**PLANNING COMMISSION REPORT**  
**Regular Agenda -Public Hearing Item**

**ITEM NO. 2A: PRELIMINARY DEVELOPMENT PLAN FOR 6<sup>th</sup> & MONTEREY WAY PCD  
MORGAN ADDITION; 800 MONTEREY WAY (MKM)**

**PDP-15-00378:** Consider a revised Preliminary Development Plan for a multi-use development consisting of *Multi-Dwelling Structures*, a *Detached Dwelling*, and *Construction Sales and Services* and associated variance from building setback requirement. 6<sup>th</sup> & Monterey Way PCD Morgan Addition, located on approximately 2.5 acres at 800 Monterey Way. Submitted by Allen Belot Architect, for Robert J. and Beverly G. Morgan, property owners of record.

**Figure 4.** Common Open Space proposed with this development outlined and hatched in orange.

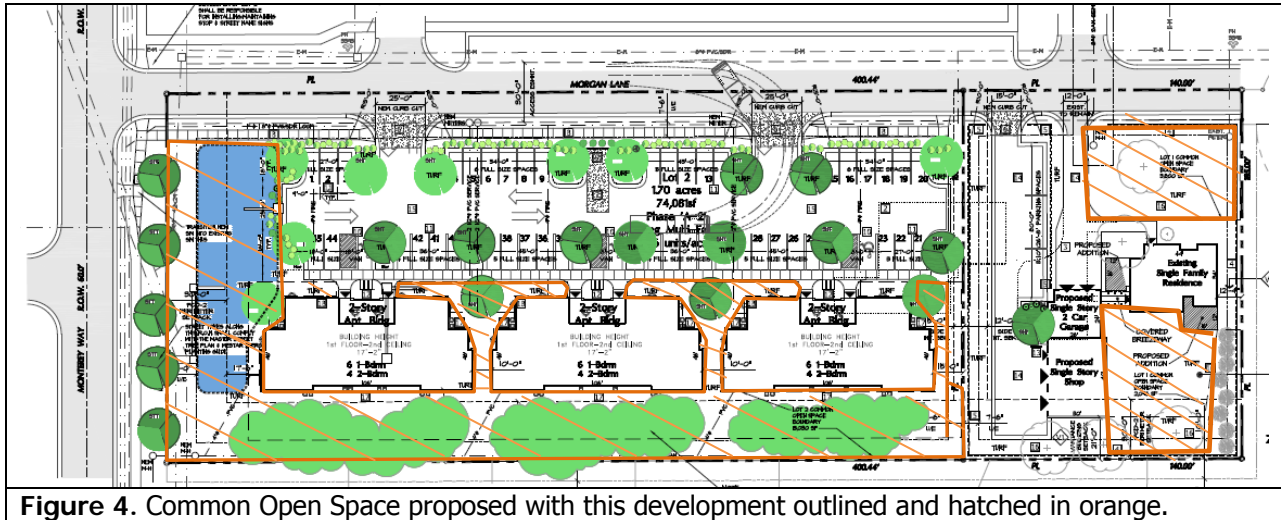
The Common Open Space shown on the plan covers more than 20% of the site. The plan should note the area within the Common Open Space and the percentage of the site. The Common Open Space is large enough to facilitate recreational uses and the placement of picnic tables and other amenities. (Figure 4)

REVISED  
PRELIMINARY  
DEVELOPMENT  
PLAN

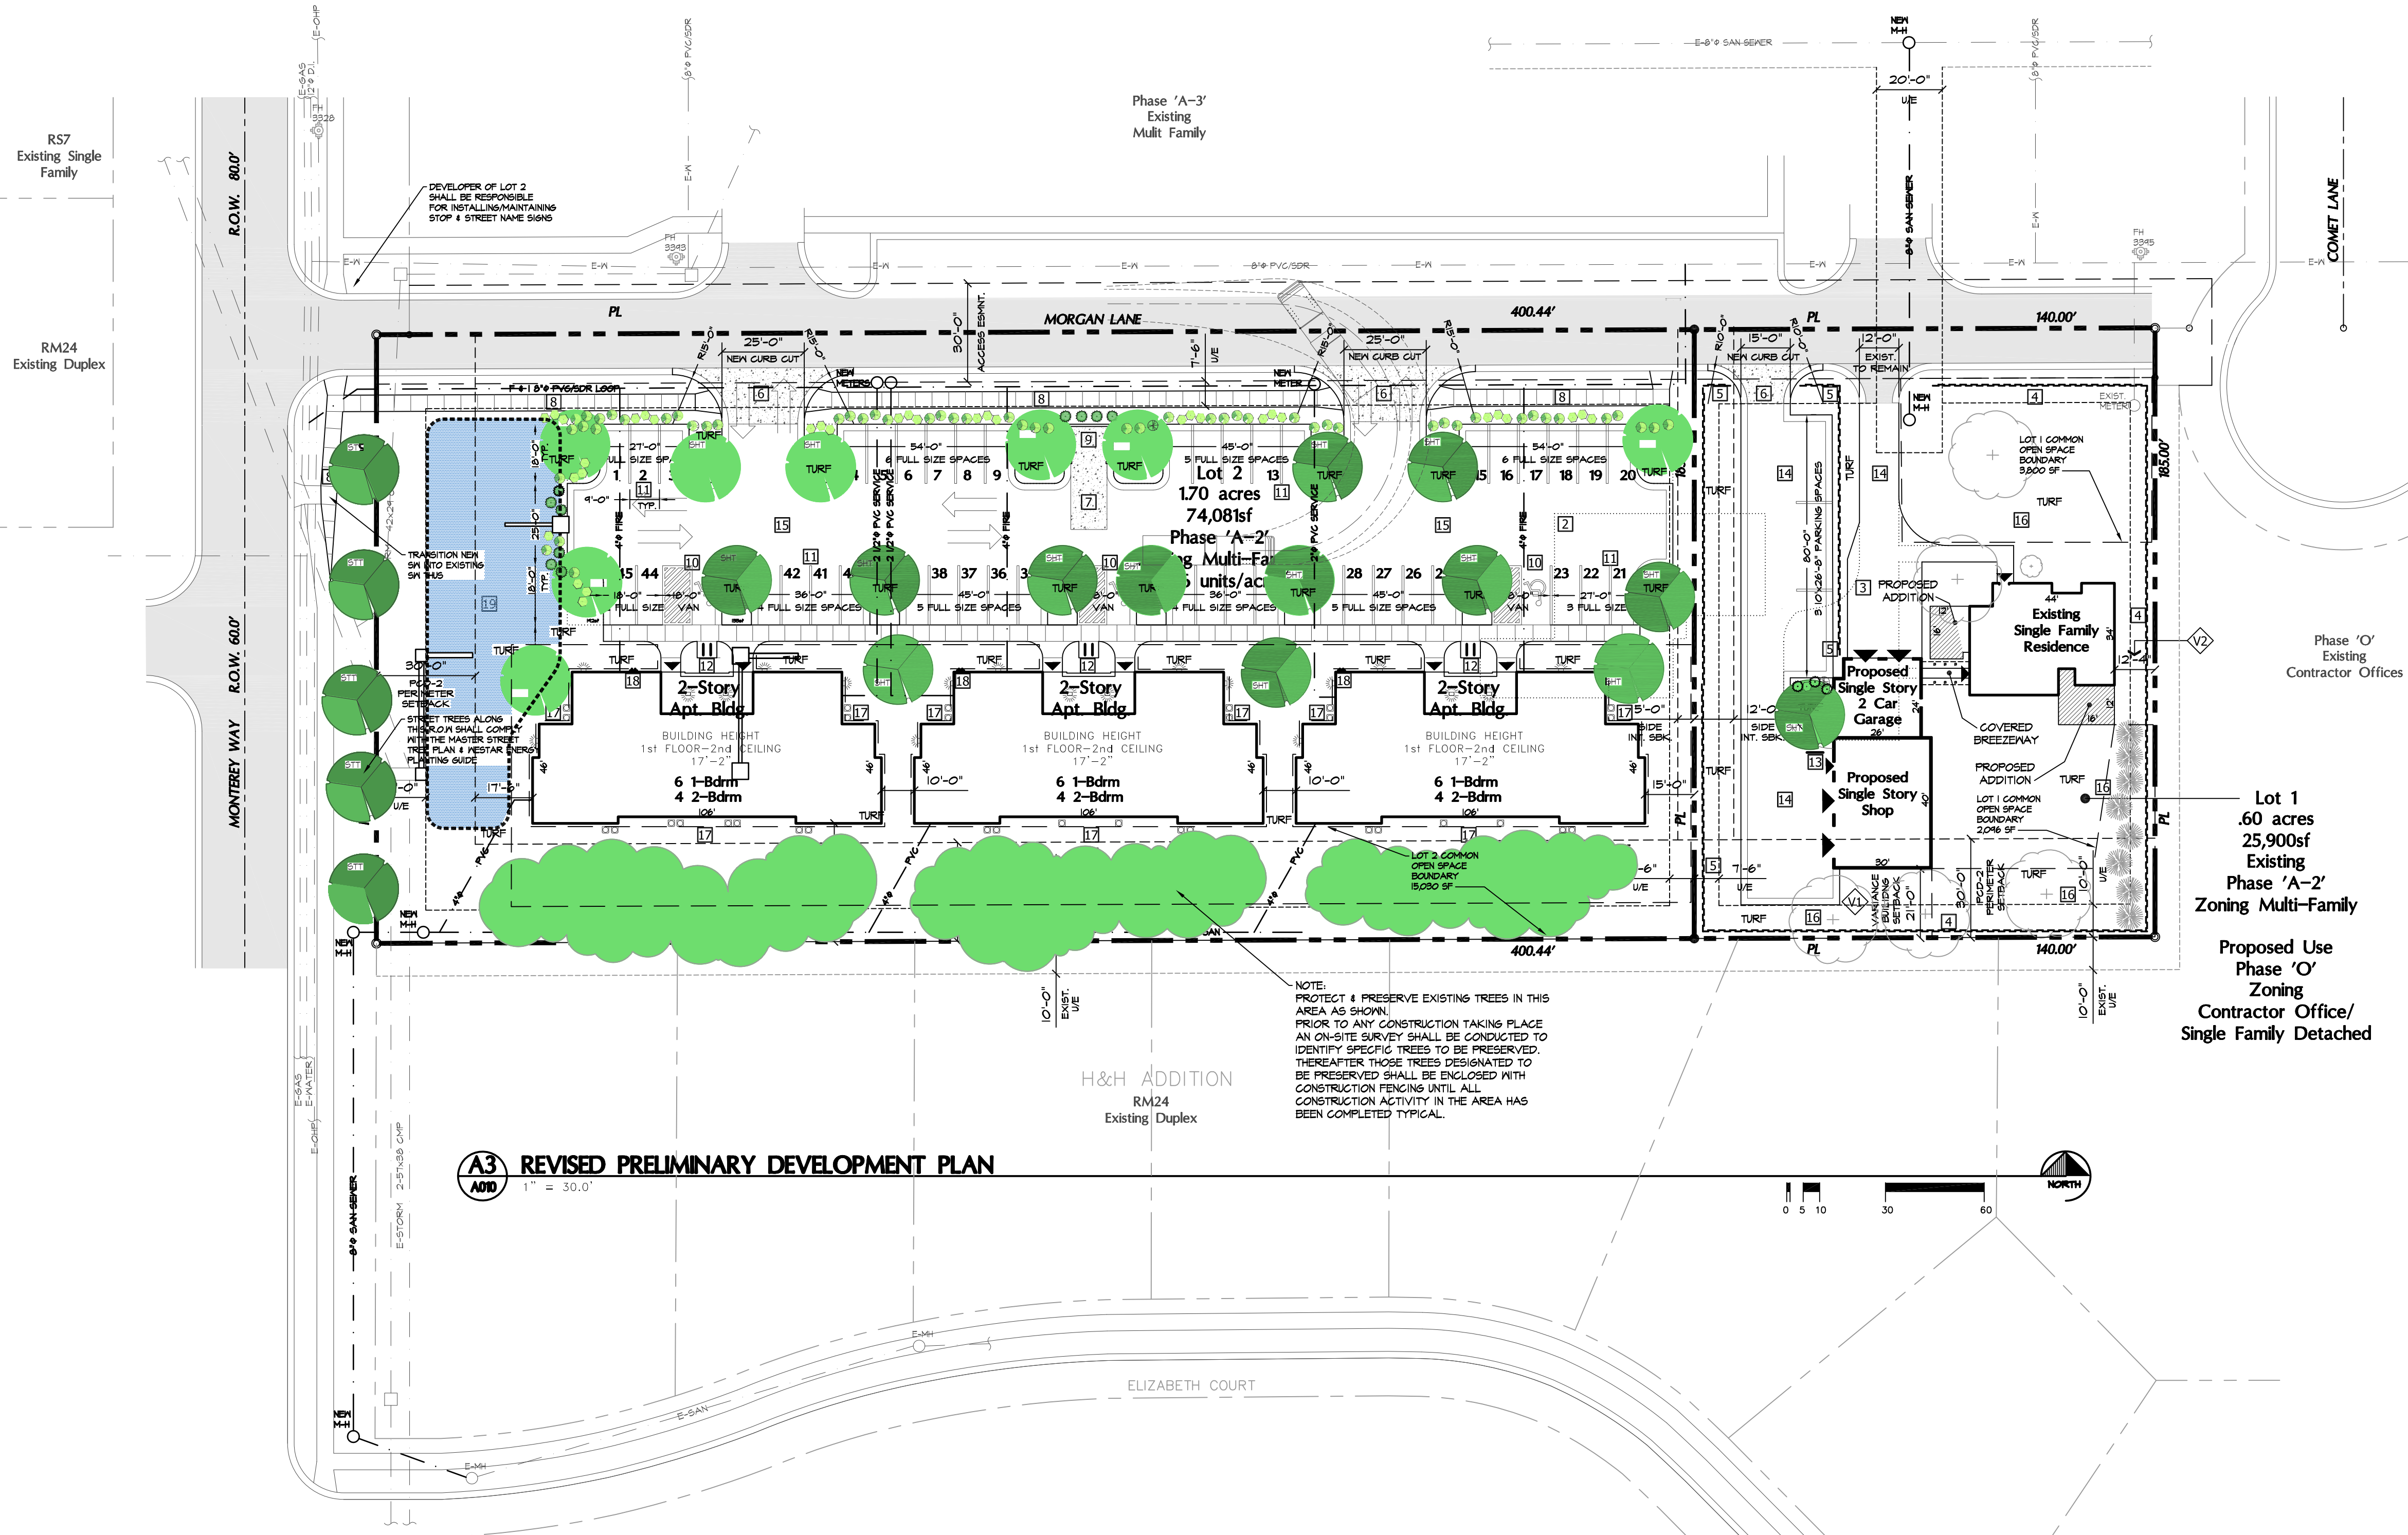
2. Provision of a revised Preliminary Development Plan with the following changes:
  - a. Include a listing of the uses which are permitted in the PDP with the revised uses in the A-2 Phase: *Detached Dwelling* and *Construction Sales and Services*.

- b. Show the complete PCD in the Preliminary Development Plan or provide a copy of the most recently approved PDP along with the revised PDP for this property.

- c. If the City Commission approves the connection to Comet Lane, list the name of the shared access (private street) and show the shared access/private street and sidewalk being extended to connect to Comet Lane.

- d. Revise the Interior Parking Lot Landscaping requirement.
  - e. Make revisions to the sanitary sewer and water lines/easements per the City Utilities Department's approval.

- f. Note the amount of Common Open Space that is being provided and the percentage of the total site area that it includes and revise the pervious surface figure in the site summary.

- g. If the variance from the southern setback is approved, show and label a fence to the south of the shop and associated access drive.

The amount of perimeter parking lot landscaping provided meets the Code requirements, but isn't listed on the plan. The species should be revised to create a continuous hedge of evergreen shrubs. These changes can be made on the Final Development Plan.
